**DATE** October 21, 2020

**TO** John Rygh  
Save the South Fork  
Pete Dronkers  
Earthworks

**FROM** Betsy Semmens, RG

I have reviewed portions of the Draft Environmental Impact Statement (*Stibnite Gold Project, Draft Environmental Impact Statement*, United States Department of Agriculture, August 2020 (DEIS, 2020, referred to hereafter as “the DEIS”)) and the following groundwater modeling reports by Brown and Caldwell (BC) to evaluate potential impacts to groundwater from proposed mining activities at the Midas Gold Stibnite mine in Idaho:

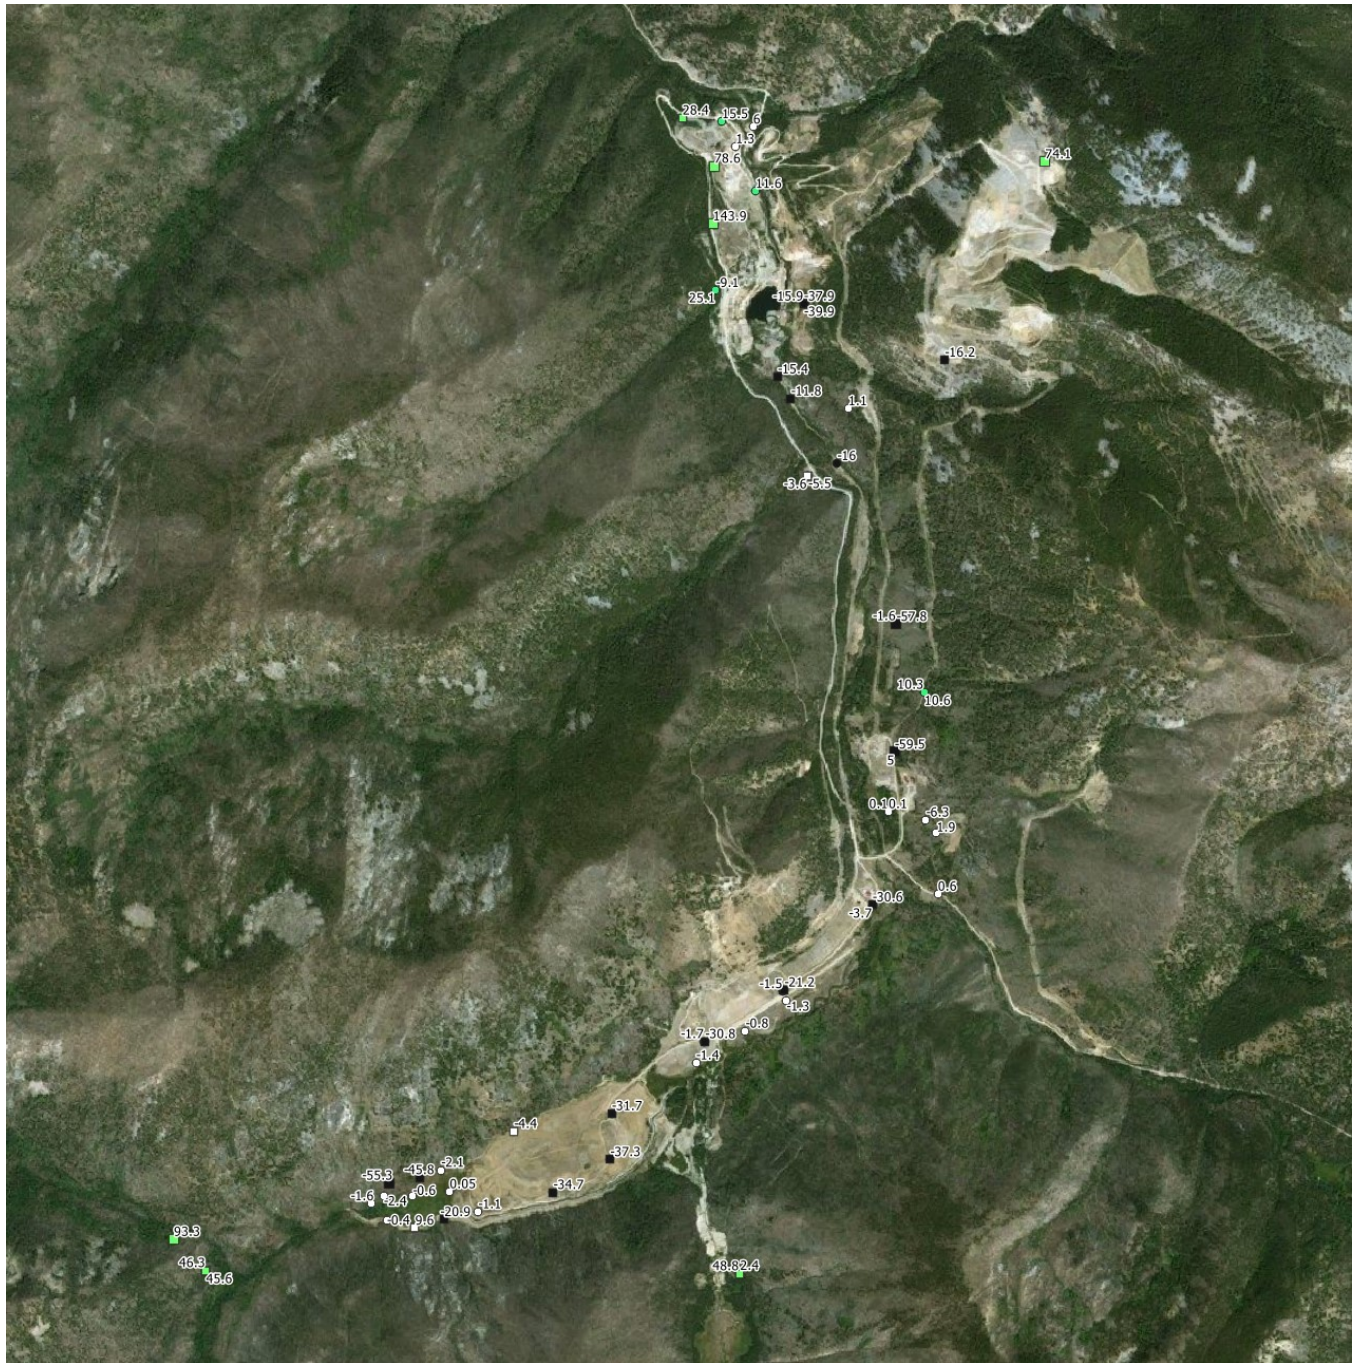
The model calibration is improved, overall, for both CA tests compared to the provided model calibration, particularly upgradient of Hangar Flats pit and near Yellow Pine pit. The difference in the absolute calibration residual for CA Test 1, for the most recent data value for each monitor well, is shown on Figure 2, and for CA Test 2 on Figure 3. A green marker indicates an improvement to the calibration, black indicates worsened calibration, and white indicates that the residual is within 10 feet of the provided model calibration. Additionally, model layer 1 residuals are represented with circles and model layer 2 with squares, and the labels are the amount the absolute residual changed from the provided model calibration (positive = improved).

Calibration residuals are unchanged (within 10 feet) or improved for all wells for CA Test 2 (Figure 3), while they are improved for wells near Yellow Pine pit and upgradient of Hangar Flats for CA Test 1 (Figure 2). The resulting calibration statistics were improved for both CA tests compared to the provided model calibration, particularly in the shallow bedrock (model layer 2). These statistics are summarized here:
